REF: SPR-30-24
DATE: July 11, 2024

| Request | - | Major Site Plan Review for a Self-Storage Facility |
| Location | - | 5055 Jackman Road |
| Applicant / Owner | - | AFS Jackman LLC

SITE PLAN

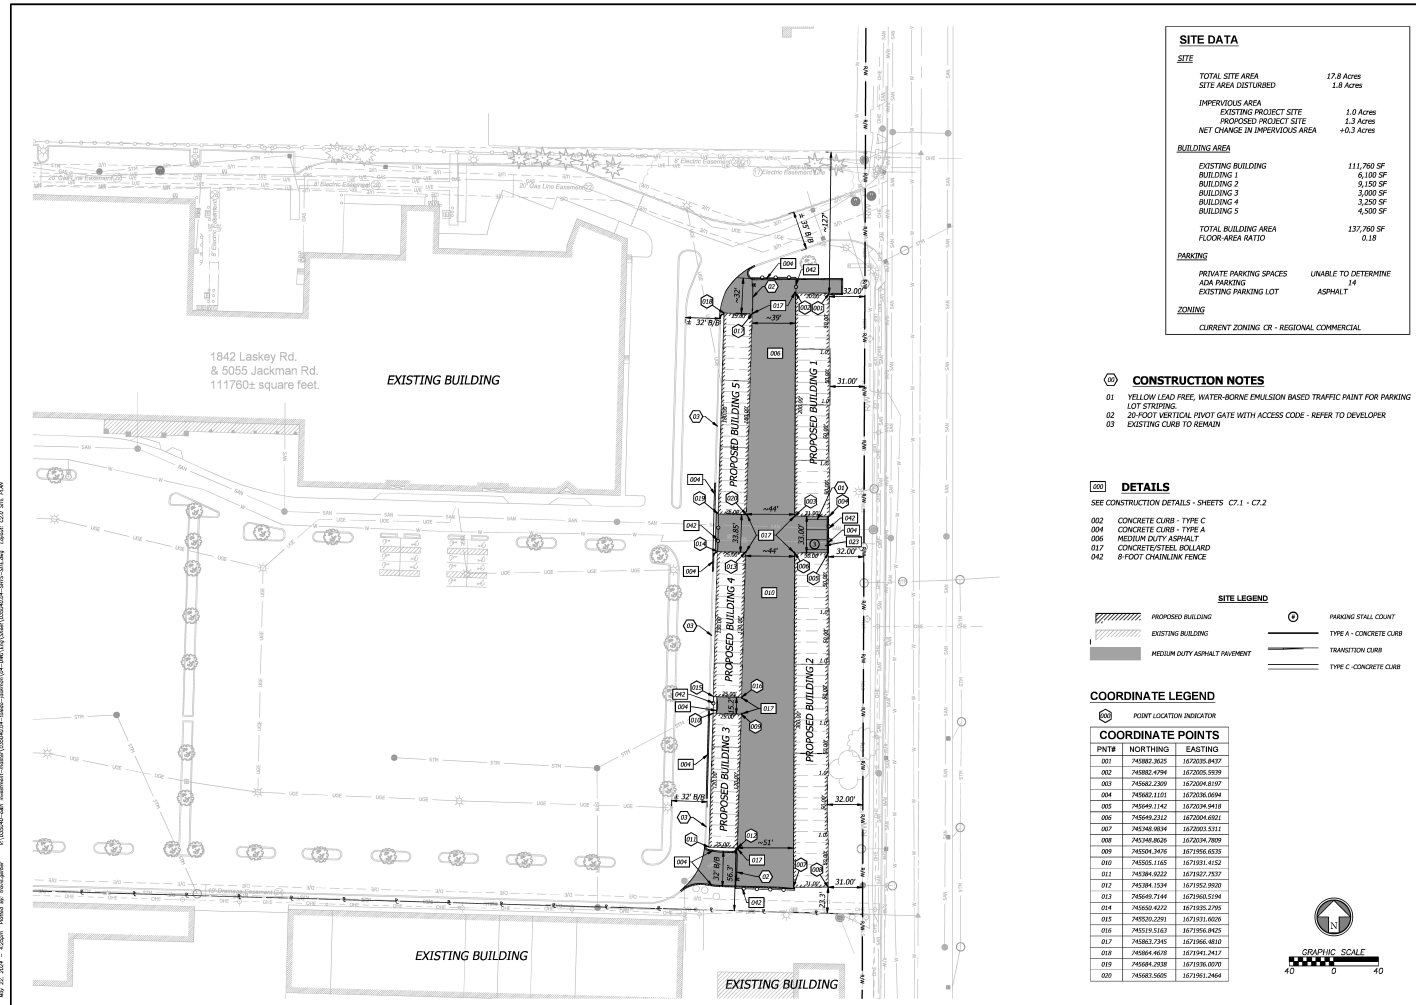
TMC§1107.0300 *Off-street parking Schedule “A”* requires a minimum of five (5) off-street parking spaces for the proposed Self-Storage Facility. The submitted site plan provides three (3) within the site plan boundaries; however, there is a large parking field on the same property to the west. The applicant intends to occupy the adjacent property and parking area along with the proposed Self-Storage Facility. These parking spaces will more than comply with TMC§1107.0300.

Accessible parking spaces must be provided according to TMC§1107.1700 *Accessible Parking for Physically Disabled Persons*. The submitted site plan shows no new accessible parking spaces. The applicant intends to use existing accessible parking spaces in the parking field to the west. Required spaces for persons with disabilities must be located in close proximity to building entrances and be designed to permit occupants of vehicles to reach the building entrance on an unobstructed path. The existing accessible parking spaces are not located withing close proximity to the proposed facility. A revised site plan shall be submitted depicting the required accessible parking spaces and listed as a condition of approval.

A minimum of one (1) bicycle parking space per ten (10) automobile parking spaces is required pursuant to TMC§1107.0300 *Off-Street Parking Schedule “A”*. None are shown on the submitted site plan, however a minimum of two (2) spaces shall be provided on site. A revised site plan shall be submitted depicting the required minimum bicycle parking and listed as a condition of approval.

Pursuant to TMC§1109.0204, at least one (1) main entrance of the facility shall face and open directly onto a five-foot (5') wide connecting walkway to the street sidewalk without requiring pedestrians to walk around buildings or around parking lot outlines which are not aligned to a logical route. Connecting walkways may cross parking aisles or driveways if distinguished from driving surfaces through the use of durable, low maintenance surface materials such as pavers, bricks, scored concrete or scored and painted asphalt to enhance pedestrian safety and comfort. Raised walkways may be installed if elevated six inches (6") with tapered side slopes and meet ADA standards. A revised site plan shall be submitted showing compliance with this section and listed as a condition of approval.

27. Off-street parking shall be provided pursuant to Off-Street Parking Schedule “A,” (TMC§1107.0304). A total of five (5) parking spaces are required for this site. The submitted site plan shows three (3) parking spaces. **Not acceptable as depicted. Revised site plan must show additional parking on the existing parking field to the west.**

28. Bicycle parking slots shall be provided pursuant to Off-Street Parking Schedule “A,” (TMC§1107.0300). Minimum number of bicycle parking slots required for mini-storage is one (1) bicycle parking per ten (10) parking spaces. **Not acceptable as depicted. Revised plan shall be submitted depicting the required minimum bicycle parking.**

29. Any spaces reserved for the use by persons with physical disabilities shall adhere to the standards outlined in TMC§1107.1700. One (1) van accessible space is required. Accessible spaces shall be located within close proximity to the building and shall be designed to permit occupants to reach the building entrance on an unobstructed path. **Not acceptable as depicted. Revised plan shall be submitted depicting the required accessible parking spaces.**

32. At least one main entrance of the facility shall face and open directly onto a 5 foot wide connecting walkway to the street sidewalk without requiring pedestrians to walk around buildings or around parking lot outlines which are not aligned to a logical route. **Not acceptable as depicted. A revised site plan shall be submitted showing compliance with TMC§1109.0204.**

LANDSCAPE PLAN

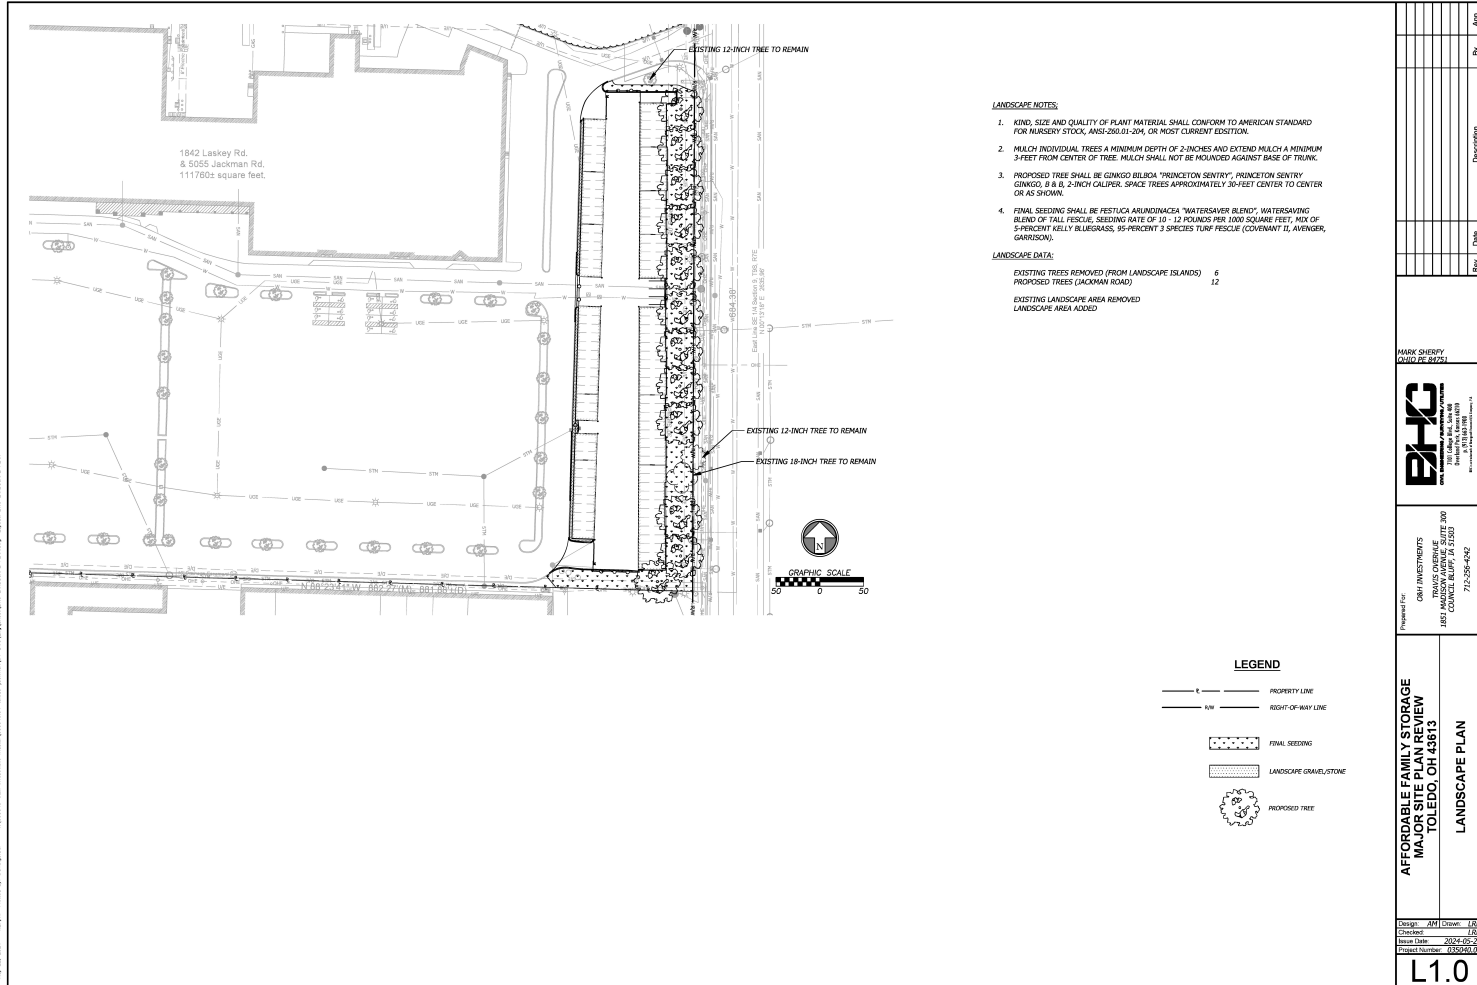
Pursuant to TMC§1108.0202 *Frontage Greenbelt*, a thirty-foot (30’) frontage greenbelt is required along Jackman Road. At least twenty-three (23) trees are required within the frontage greenbelt. The submitted landscaping plan shows fifteen (15) trees – three (3) of which are existing. TMC§1108.0407 *Tree Preservation and Credit For Existing Landscape Materials* permits the applicant to use these preserved trees as landscape material credits. Based upon their caliper shown on the submitted landscaping plan, these three (3) trees equate to fourteen (14) tree credits. Trees shown on the submitted landscaping plan comply with TMC§1108.0202 *Frontage Greenbelt*; however, a solid evergreen hedge is required along the parking area fronting on Jackman Road. A low decorative stone or brick wall would also be acceptable to meet this requirement. A revised landscaping plan shall be submitted depicting the required evergreen hedge, or wall, along the parking area facing Jackman Road and listed as a condition of approval.

Pursuant to TMC§1108.0204, a perimeter landscape buffer ten feet (10') in width is required along the southern end of the facility's internal drive aisle. Such perimeter landscape buffer shall include at least one (1) canopy tree and a continuous shrub with a minimum height of eighteen inches (18"). A decorative stone or brick wall will also be acceptable to meet this requirement. A revised landscaping plan shall be submitted depicting the perimeter landscaping and listed as a condition of approval.

In addition to the other landscape requirements for buffer areas and frontage greenbelts, one (1) tree is required for every 1,000 square feet of building coverage and two (2) canopy trees and six (6) shrubs are required for each ten (10) parking spaces. The proposed buildings combined total twenty-six thousand (26,000) square feet and a minimum of five (5) parking spaces are required for the facility. Twenty-eight (28) trees and six (6) shrubs are required. The submitted landscaping plan does not depict any of these required plantings. A revised landscaping plan shall be submitted depicting the interior site landscaping and listed as a condition of approval.

Foundation plantings are required along all portions of the building that are visible from the public rights-of-way. Foundation plantings shall be provided along visible elevations to the north and south of buildings one, two, three, and five. A revised landscaping plan shall be submitted depicting foundation plantings and listed as a condition of approval.

- b. If a parking lot is proposed to be developed in the front of the property, the frontage greenbelt shall include a solid evergreen hedge planting to screen the parking lot so that no headlights of any vehicles can be seen from the public street. **Not acceptable as depicted. Hedge or low brick or stone wall is required along parking area fronting Jackson Street. Revised landscaping plan shall be submitted depicting the required evergreen hedge, or wall, along the parking area facing Jackman Road.**

- c. A perimeter landscape buffer ten feet (10’) in width is required along the southern end of the facility’s internal drive aisle. Such perimeter landscape buffer shall include at least one (1) canopy tree and a continuous shrub with a minimum height of eighteen inches (18”). **Not acceptable as depicted. One (1) canopy tree and a continuous shrub is required. Low brick or stone wall may be used as a substitute for continuous shrub. Revised landscaping plan shall be submitted depicting the required perimeter landscaping.**

- d. Two (2) canopy trees and six (6) shrubs are required to be installed in interior landscape areas for each ten (10) parking spaces within the parking lot. Two (2) trees and six (6) shrubs are required for this site. **Not acceptable as depicted. Two (2) additional trees and six (6) additional shrubs are required. Revised landscaping plan shall be submitted depicting the required plantings.**

- e. One 2-inch caliper tree for every 1,000 square feet of building coverage shall be required. Twenty-six (26) trees are required for this site. As long as the required buffer areas are sufficiently screened, the additionally required trees may be placed anywhere on the parcel. **Not acceptable as depicted. Approval of final landscape plan will be upon the discretion of the Planning Director.**

- f. Foundation plantings shall be required along the portions of the building visible from the right-of-way. **Not acceptable as depicted. Foundation plantings shall be provided along visible northern and southern façades and shown on a revised landscaping plan.**
